CERTIFICATE OF APPROPRIATENESS

Property: 1720 White St, Tracts 11 and 12, Block 314, Shearn Subdivision. The property includes a historic 1,147 square foot, one-story wood frame single-family residence situated on a 2,950 square foot (47' x 63') interior lot.

Proposal: Alteration – Addition/Windows/Porch

WEST ELEVATION – FRONT FACING WHITE

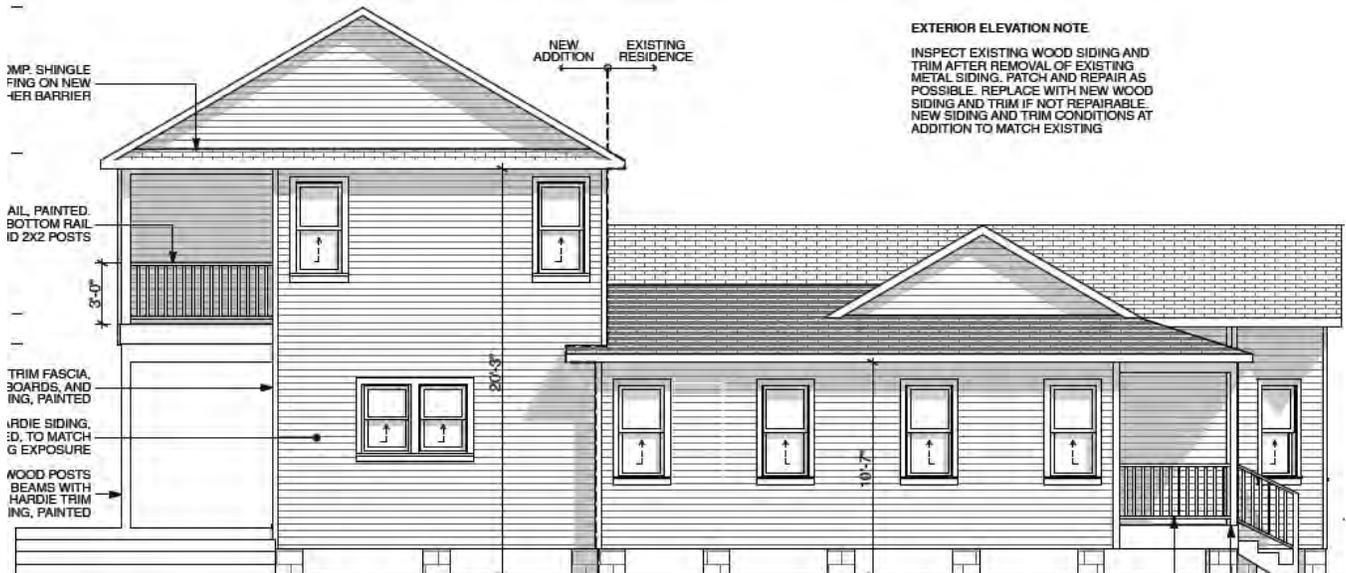
<i>Altering the original fenestration pattern on the south elevation of the existing residence does not preserve the distinguishing qualities or character of the building.
The addition's gable roof overpowers the existing residence creating a significant visual impact. The gable roof is not compatible with the existing residence's simple massing, and therefore does not preserve the distinguishing qualities or character of the building.</i> |

SOUTH SIDE ELEVATION

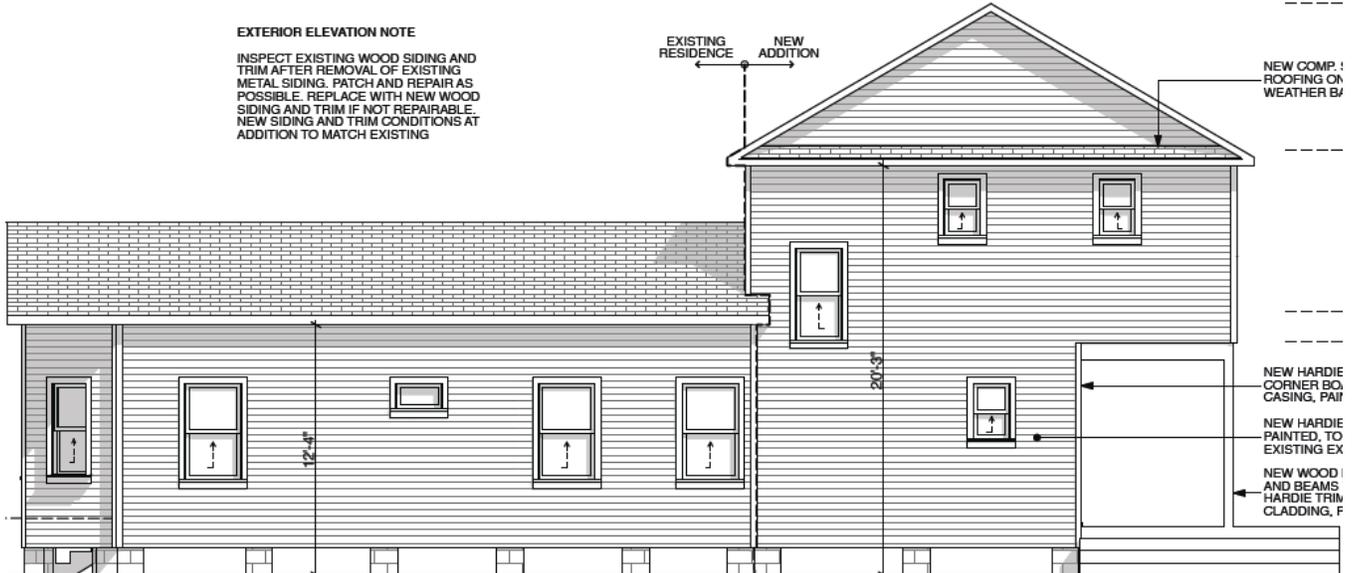
Recommendation: **Approval with conditions:** Approval with the condition that the applicant (1) retain the historic fenestration pattern on the south side elevation; and (2) hip the addition's roof with a pitch not to exceed 6/12.

<i>Altering the original fenestration pattern on the south elevation of the existing residence does not retain or preserve the historical character of the property because it disrupts the existing solid-to-void pattern indicative of early structures.
The addition's gable roof overpowers the existing residence creating a significant visual impact. The gable roof is not compatible with the existing residence's simple massing, and therefore does not retain or preserve the historical character of the property.</i> |

<i>Altering the historic fenestration pattern on the south elevation of the existing residence creates a later appearance by disrupting the existing solid-to-void pattern indicative of early structures.</i> |

<i>In addition to altering the historic fenestration pattern on the south elevation, the applicant proposes to increase the size of the existing openings which will require extensive reframing, resulting in a loss of historical and architectural material.</i> |
